HERITAGE IMPACT ASSESSMENT

1007 Beach Boulevard, Hamilton, ON

Left: FRONT SETBACK: the front setback matches the setback of the adjacent dwelling to the north
 Right: FRONT ELEVATION: two identical 2-storey dwellings are proposed that are 10.3 m in height

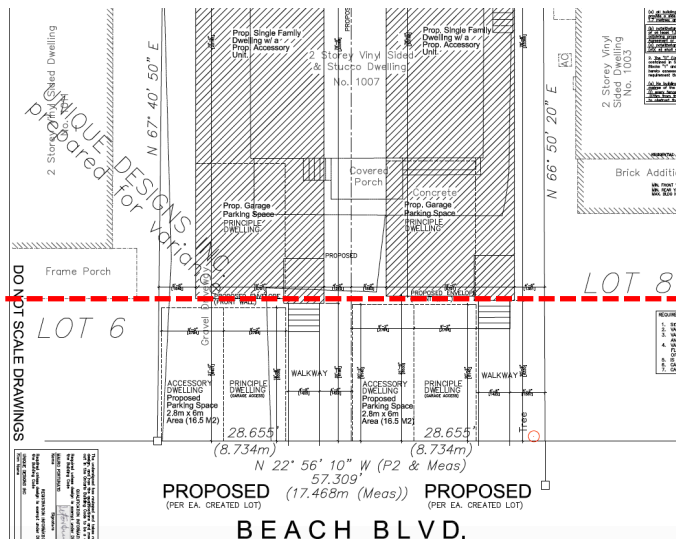
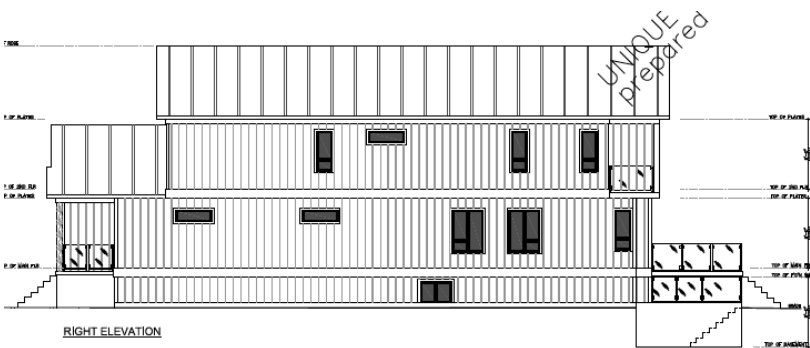
- the garage is integrated into the front façade instead of located at the rear
- the front yard is entirely paved and does not include any landscaping

- the garage is integrated into the front façade instead of located at the rear
- the front yard is entirely paved and does not include any landscaping

REVISED DRAWINGS

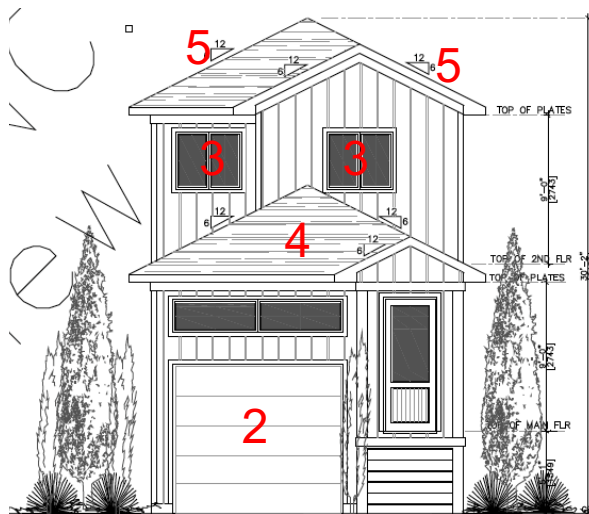
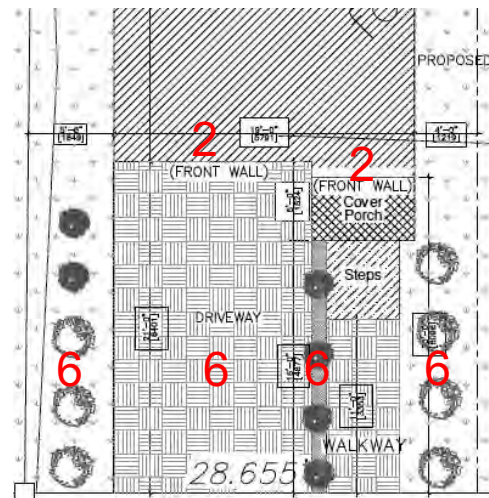
The proposed lots are not wide enough to accommodate a side driveway, so locating the garage beside or behind the house is not feasible. However, the impact of the garage on the streetscape

could be minimized by setting it further back and by introducing landscape elements in the front yard.

The following revisions have been made:

1. the 2nd floor has been pushed forward to better integrate the garage into the overall massing and reduce its visual impact on the street
2. the garage wall has been set back from the front wall of the house and covered porch projects forward to address the street

3. the windows on the front elevation have been adjusted so that they are more balanced and symmetrical
4. the height of the garage roof has been lowered to reduce the visual impact of the garage from the street and a hipped roof has been introduced for the garage to give it a more compact massing

5. the roof slopes of the main roof have been reduced so that the 2nd floor can have a more balanced appearance
6. landscape components have been introduced to enhance the streetscape including permeable pavers on the driveway, and plantings in the front and side yards (The intent is illustrated in the updated rendering. Details will be provided in a forthcoming Landscape Plan if the severance application is approved by the Committee of Adjustment).

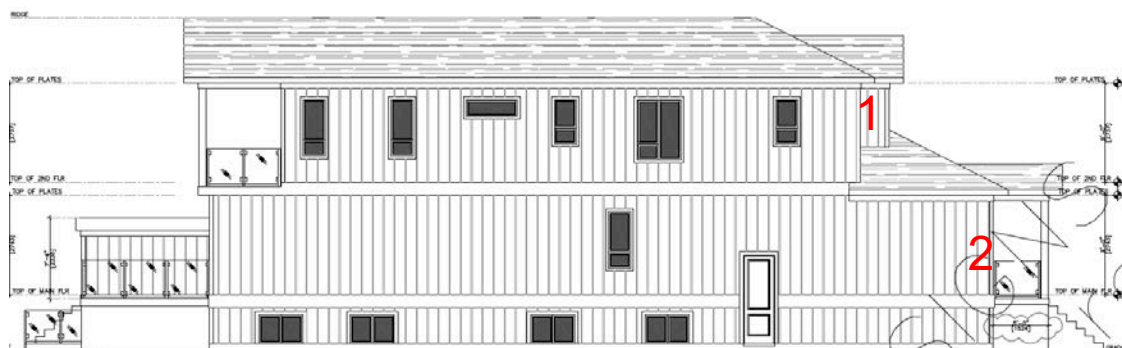
- set the garage back from the front wall of the house
- reduce the amount of paving in front of the houses and introduce new landscaping

UPDATED RENDERING – the applicant proposes to build two identical houses with painted wood board & batten style cladding – the rendering shows the applicants intent regarding the landscaping that will be detailed in a detailed Landscape Plan if the severance is approved. The final cladding materials, garage door and landscape plan will be provide to heritage staff for final approval.
